Order Instituting Rulemaking to Oversee the Resource Adequacy Program, Consider Program Refinements, and Establish Annual Local Procurement Obligations.

Rulemaking R.11-10-023
(Filed October 20, 2011)

**COMMENTS OF MEGAWATT STORAGE FARMS, INC.
ON THE
January 24, 2014 WORKSHOP STAFF PROPOSALS**

February 18, 2014

Figure 1: Impact of 1000 MW of 1.5 Hour Storage on 10,000 MW 3 Hour Net Load Ramp

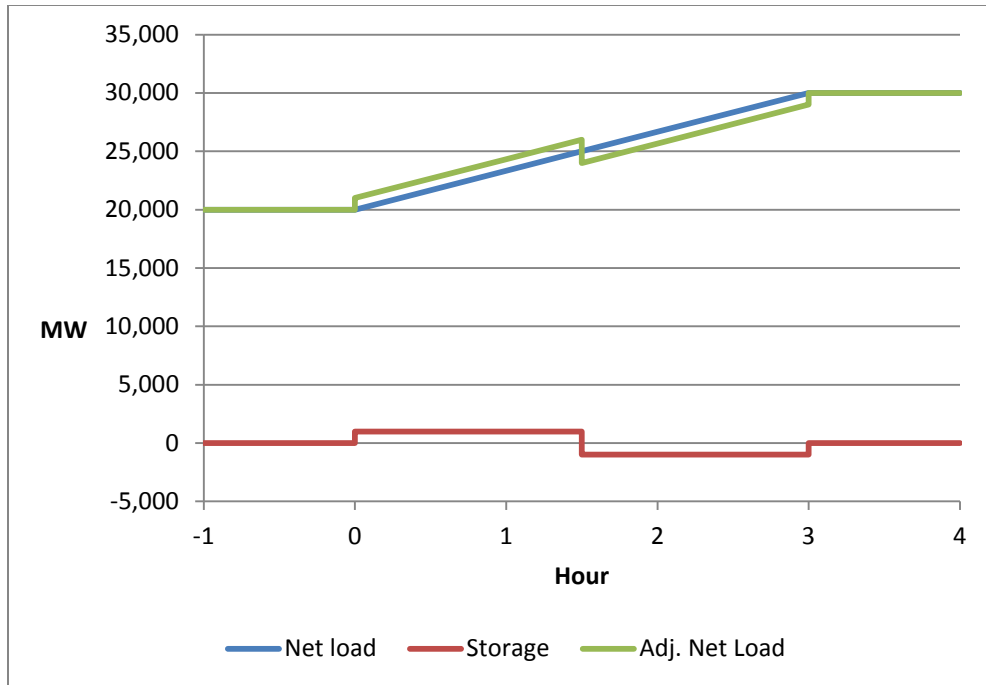
Figure 1 below illustrates this staff proposal case. As shown at the bottom of the figure, a storage facility with 1000 MW P_{\min} and 1000 MW P_{\max} and 1.5 MWH of energy storage is first charged for 1.5 hours at P_{\min} and then discharged for 1.5 hours at P_{\max} .

The figure also shows an illustrative net load of 20,000 MW before time 0 and a 10,000 MW up-ramp over 3 hours to a 30,000 MW net load. The figure also shows the net load adjusted for this storage dispatch.

The figure shows that 1.5 hours of storage dispatch has no net impact on the 3-hour ramp. Furthermore, the increased up-ramp in the first 1.5 hours is likely to complicate the dispatch of other resources to meet the overall ramp.

MegaWatt would support a requirement that the negative output of storage also meet the full 3 hour ramp to set the P_{\min} for full EFC credit.

Figure 2: CAISO 2020 Net Load with 4 GW of 4- Hour Storage

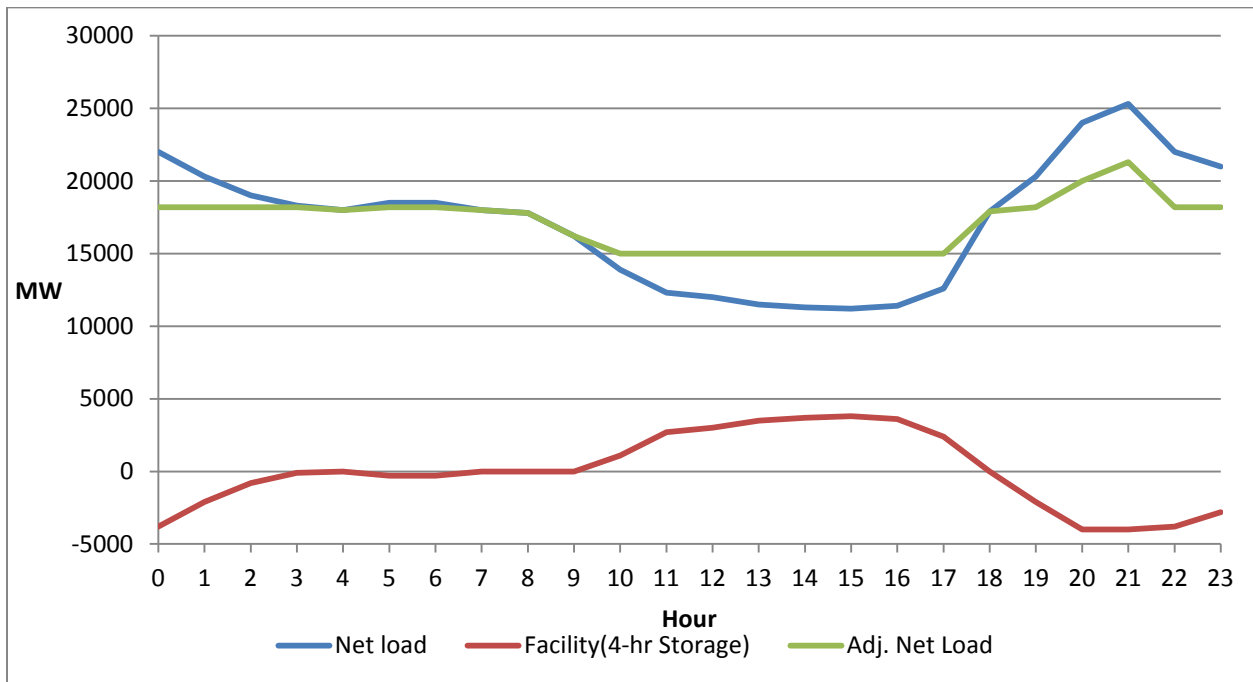
Also shown on the figure is an illustrative dispatch of 4 GW of storage with 4 hours of energy¹. The adjusted net load after application of the storage greatly reduces the net load ramp.

Figure 3: CAISO 2020 Net Load with 4 GW of 1.5- Hour Storage

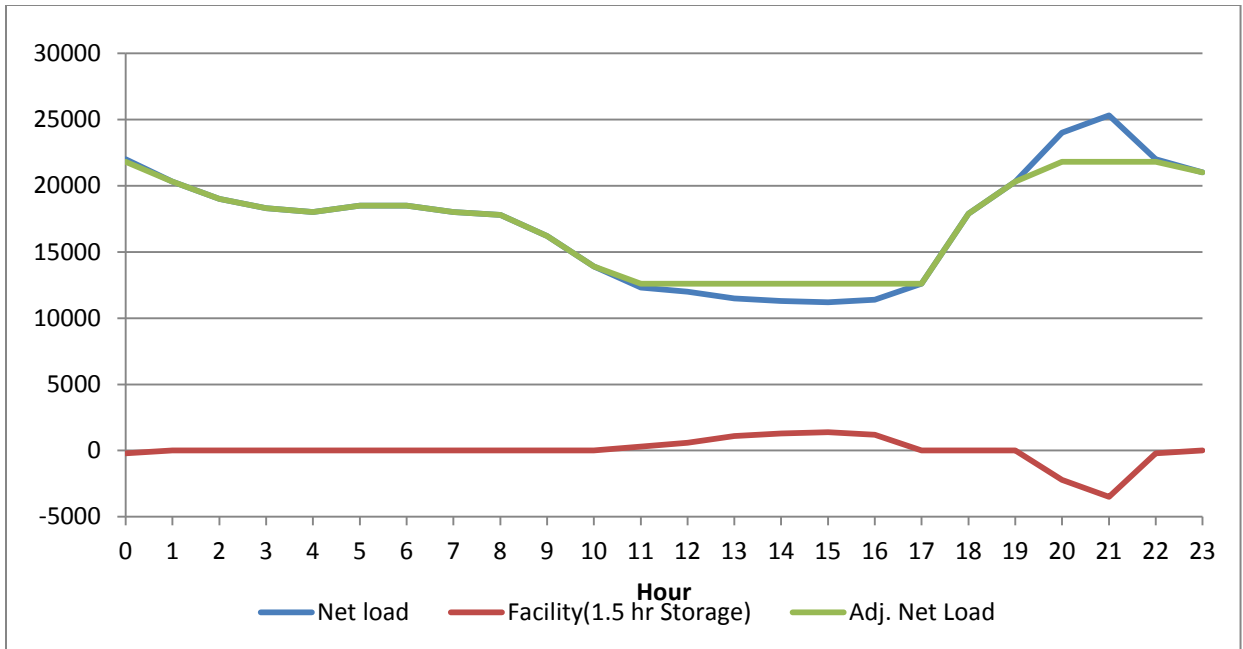
Figure 3 shows the same example with 1.5 hours of storage.

The graphs show that 1.5 hours of storage has smaller impact on the net load ramp and potential over generation at the base of the “Duck” relative to 4 and 6 hours of storage. Hence, from a longer-term perspective, QC and EFC requirements that favor short duration 1.5-hour storage will support much less renewables integration than storage facilities that are required to have 3 to 4 hours or more of storage.

Figure 4: CAISO 2020 Net Load with 4 GW of 6- Hour Storage

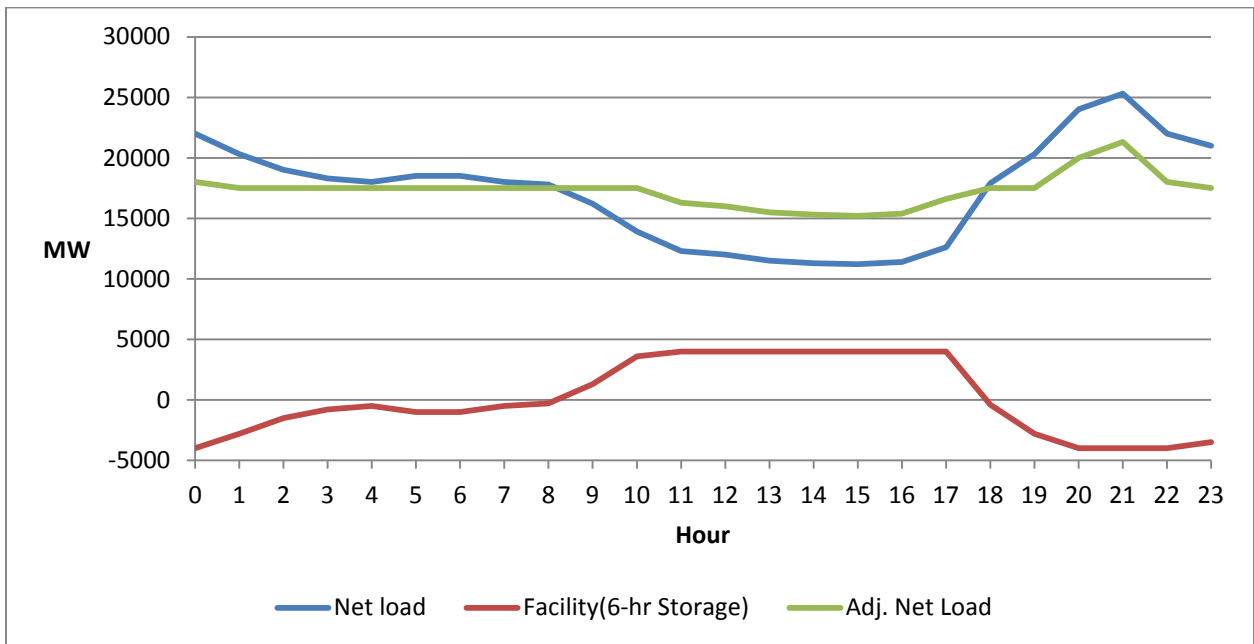
Figure 4 shows the example with 6 hours of storage.
